**Stowey Quarry Restoration Using SNRHW and
Inert Wastes**

**Response to Comments Received up to 21 March
2011 on Application No. 10/05199/MINW**

Document Ref.
2055-126-G

Drawing of wheel wash system

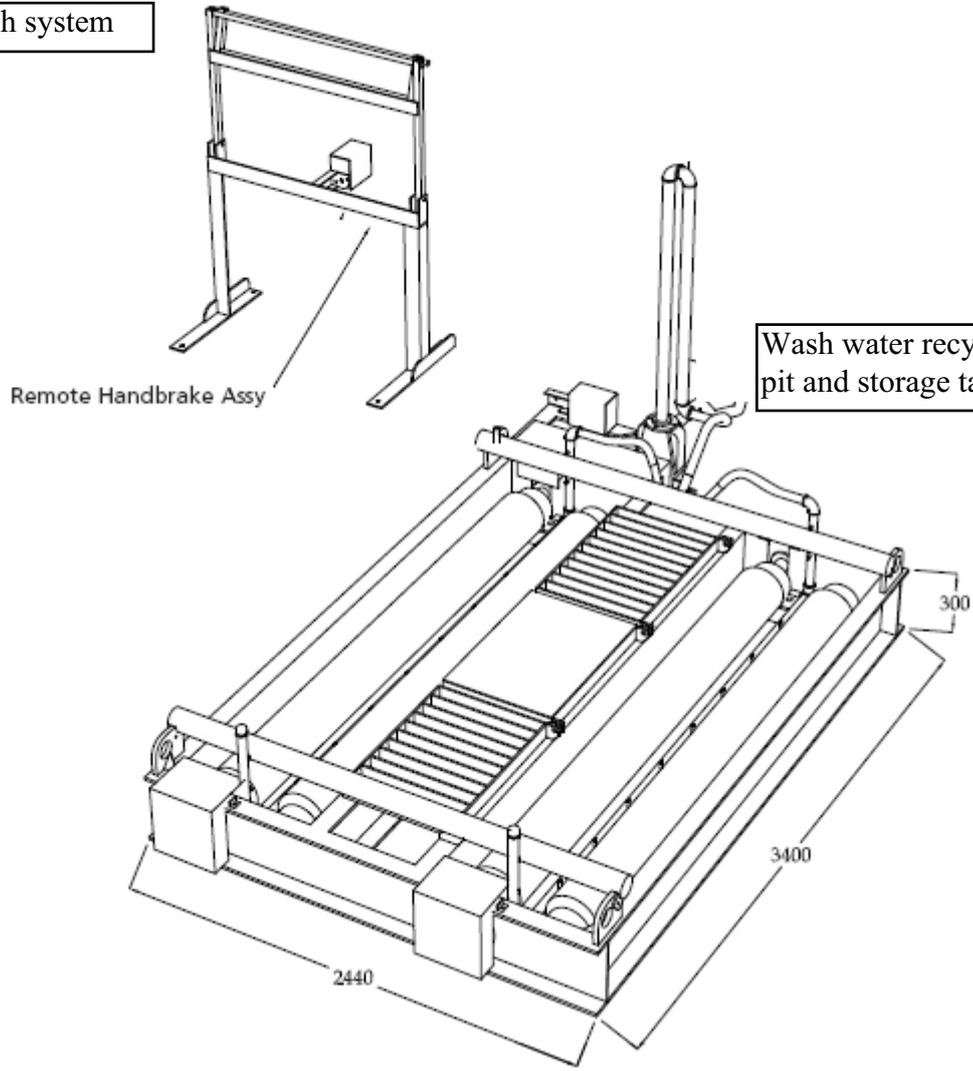
- 7.9 Appendix I of this document contains an example of a proposed wheel washing system for the site. Details of the exact wheel washing facilities to be used at the site will be submitted to the Local Planning Authority prior to commencement.
